# Decision Document

**Works Approval:** W5830/2015/1

**Premises address:** Allawuna Farm Landfill  
2556 Great Southern Highway  
ST RONANS WA 6302  
Being Part of Lot 4869 on Plan 224502 as depicted in Appendix C and defined between the following Global Positioning System positions:

Works approval W5830/2015/1 has been granted for the construction of Cells 1 and 2 of a Class II putrescible landfill located at Lot 4869 Great Southern Highway in Saint Ronans. The landfill meets the description and design capacity of a Category 64 landfill as defined in Schedule 1 of the *Environmental Protection Regulations 1987*. The Premises is located on a portion of the Allawuna Farm, an area of approximately 1,500 hectares, which consists of approximately 75% of cleared land for sheep grazing and broad acre crop production with the remaining 25% consisting of remnant vegetation. The landfill footprint area is approximately 36 hectares with the remainder of the property proposed to remain under the current land use arrangements, which is incorporated into the specified prescribed premises boundary within Lot 4869.

Figure A3.1: Proposed Landfill Liner Design (Source: Golder Report, Appendix B)

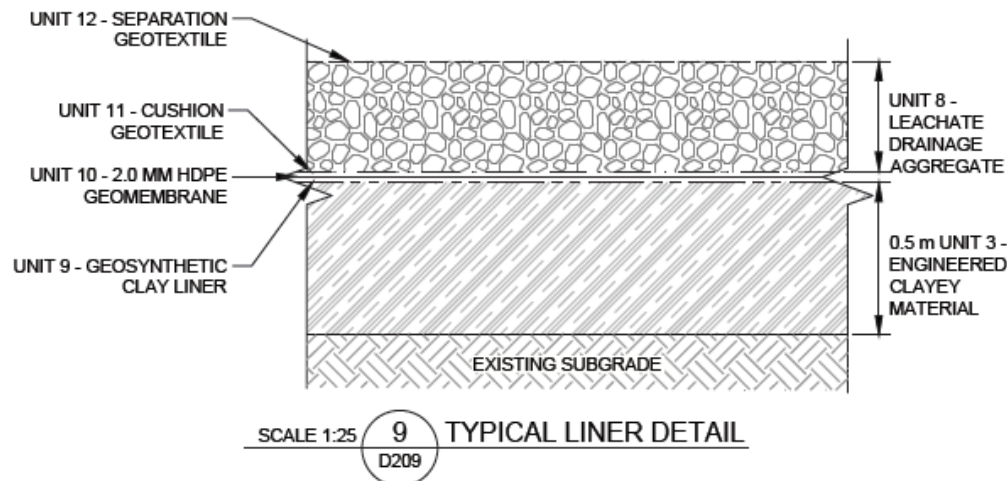
An assessment of the proposed liner design provided in the Golder Report has been undertaken and the CEO's delegate considers it appropriate. The following summarises the main components as depicted in Figure A3.1:

The Golder Report indicates that the material is likely to achieve compaction to a permeability of  $1 \times 10^{-8}$  m/s. The CEO's delegate notes that the permeability of this material has not been considered in the assessment of risk to groundwater. The liner, as designed provides adequate containment.

**Figure A4.3: Leachate collection system within liner drainage layer (Source: Golder Report, Appendix B)**

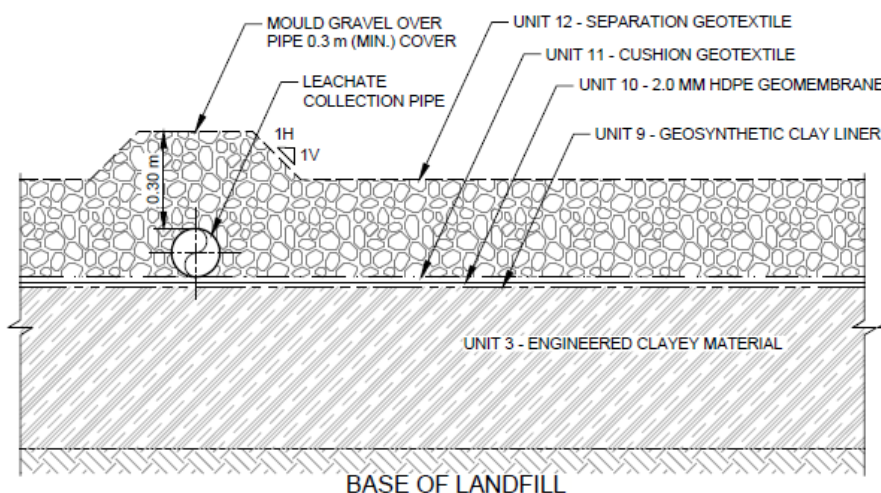
- The leachate collection system is incorporated into the liner system within the leachate drainage aggregate layer. Perforated pipes are installed within this drainage layer to capture leachate generated within the cell (as depicted in Figure A4.3).

**Figure A9: Capping components (Image provided by Golder Associates Pty Ltd)**

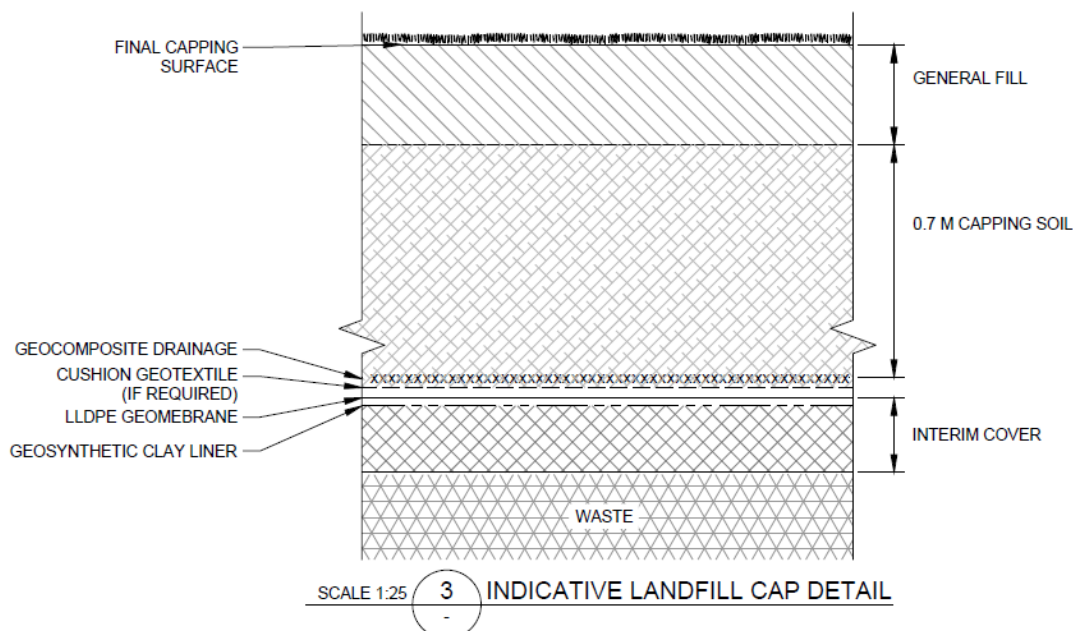
be developed in accordance with the above specification and that the GHD stability review considers this capping to be stable, the CEO's delegate is satisfied that the proposed capping is acceptable.

Figure 1 Summary of municipal solid waste strength data (based upon Singh and Murphy, 1990, source ref.1)

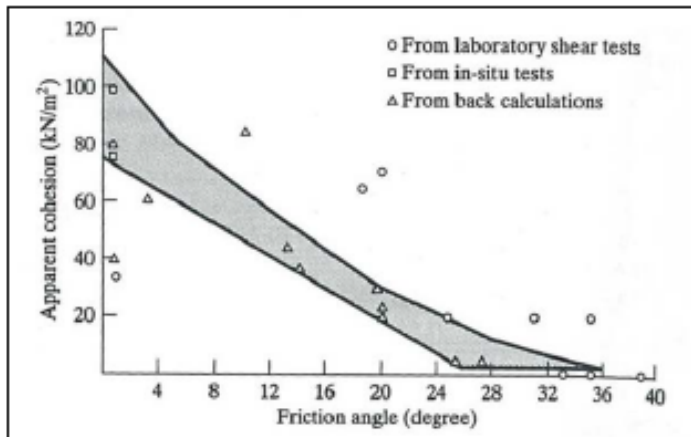
The strength parameters attributed to the waste as presented within Table 5 of Appendix F ( $\psi' = 25^\circ$  and  $c' = 5\text{kPa}$ ) are considered lower bound based on published values as shown in Figure 1.

It is considered that increasing the effective cohesion of the waste material may result in the minimum FoS for waste stability under MCE conditions (Appendix F output Figure B8) increasing to from 0.95 above 1.0.
